TRUSS REPAIR

TC LL	16.0 PSF	REF R215-- 10807
TC DL	10.0 PSF	DATE 04/21/06
BC DL	10.0 PSF	DRW HCUSR215 06111203
BC LL	0.0 PSF	HC-ENG RA/AF
TOT. LD.	36.0 PSF	SECON- 62809 REV
DUR. FAC.	1.25	FROM CDM
SPACING	24.0"	JREF - 15W0215_207

TRUSS REPAIR

QTY: 0	FL: -/5/-/-/R/F	Scale = .1875"/Ft.
TC LL	16.0 PSF	REF R215-- 10807
TC DL	10.0 PSF	DATE 04/21/06
BC DL	10.0 PSF	DRW HCUSR215 0611202
BC LL	0.0 PSF	HC-ENG RA/AF
TOT. LD.	36.0 PSF	SEQN- 62779 REV
DUR. FAC.	1.25	FROM CDM
SPACING	24.0"	UREF- 15W0215_207

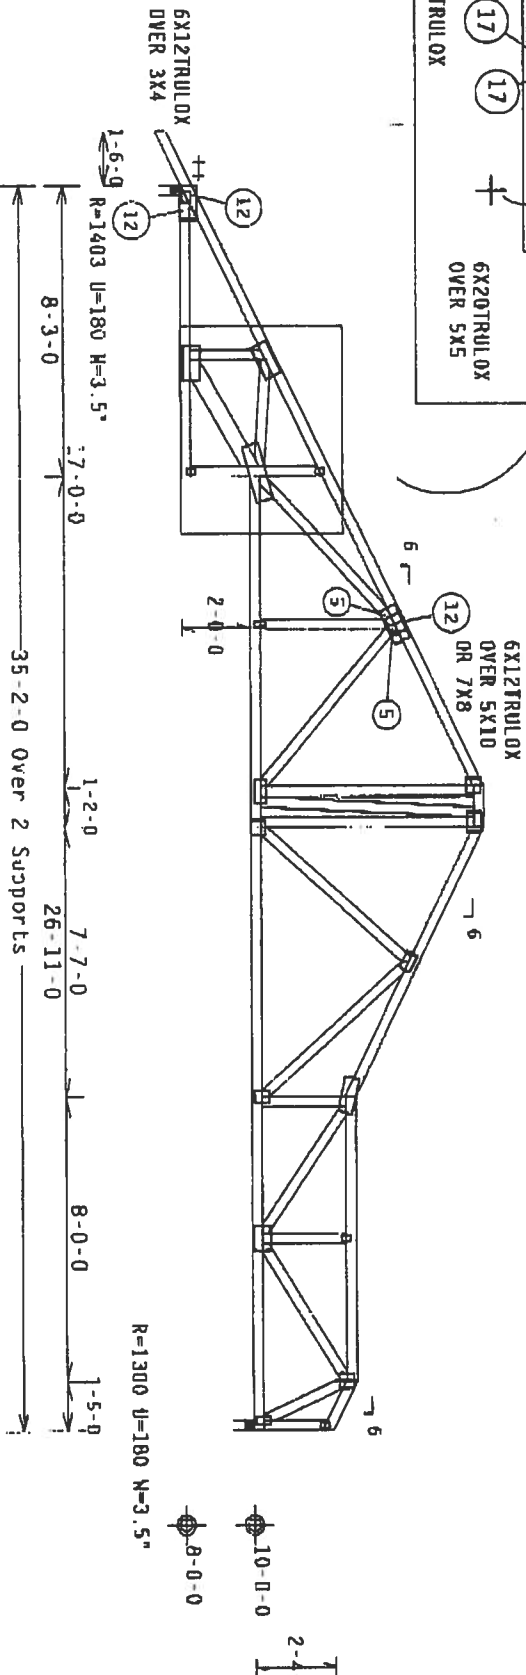
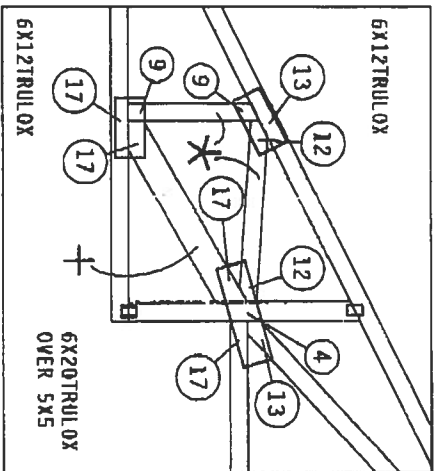
REPAIR TO REMOVE INTERIOR BEARING AS SHOWN.

FIELD REPAIR MUST COMPLY WITH ALPINE DESIGNS AND SPECIFICATIONS.

11 GAUGE (0.120")X1.375" nails required for trulox plate attachment. Nails specified in circles must be applied to each face of each truss ply. See DWG 160TL for nailing and trulox plate requirements.

+ BEND OR CUT THE TRULOX PLATE TO CONFORM WITH THE TRUSS GEOMETRY.

*NEW MEMBERS ADDED:
2X4 SP #2 OR BETTER (CUT TO FIT). ATTACHED WITH TRULOX PLATES AS SHOWN.

*NEW MEMBERS ADDED:
2X6 SP #2 OR BETTER (CUT TO FIT). ATTACHED WITH TRULOX PLATES AS SHOWN.

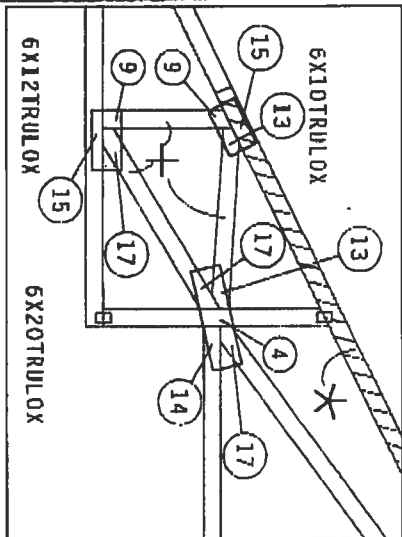
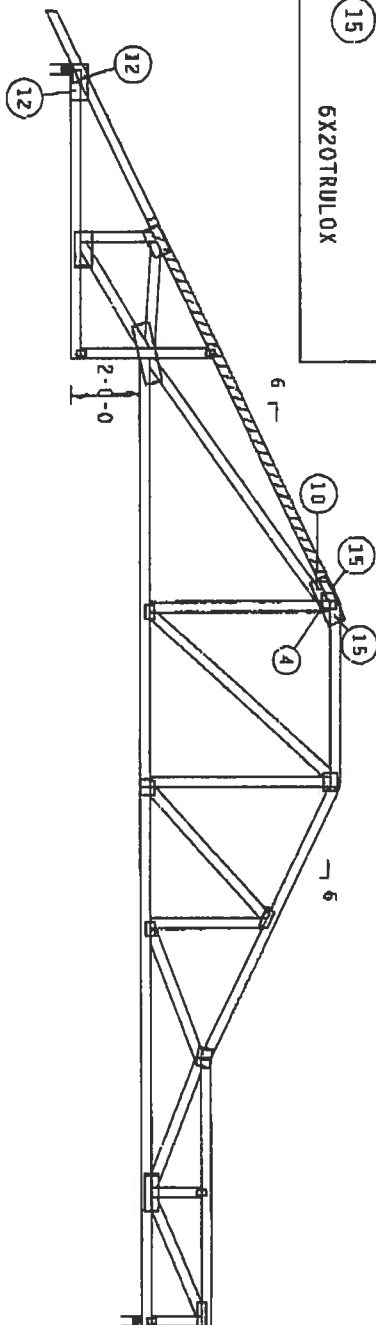
REPAIR TO REMOVE INTERIOR BEARING AS SHOWN.
FIELD REPAIR MUST COMPLY WITH ALPINE DESIGNS AND SPECIFICATIONS.

11 GAUGE (0.120")X1.375" nails required for trulox plate attachment. Nails specified in circles must be applied to each face of each truss ply. See Dwg 16011 for nailing and trulox plate requirements.

++ BEND OR CUT THE TRULOX PLATE TO CONFORM WITH THE TRUSS GEOMETRY.

* (1) 2X4X12-0-0 SP #2 OR BETTER SCAB. ATTACH SCAB TO ONE FACE OF TRUSS, CENTERED ON BREAK, WITH 0.131"X3.0" GUN NAILS AT 8" O.C. IN EACH ROW, STAGGER NAILS IN ADJACENT ROWS 4" THROUGHOUT. REFER TO DRAWING CMMALSP1103 FOR NAIL SPACING INFORMATION.

+NEW MEMBERS ADDED:
2X4 SP #2 OR BETTER(CUT TO FIT). ATTACHED WITH TRULOX PLATES AS SHOWN.
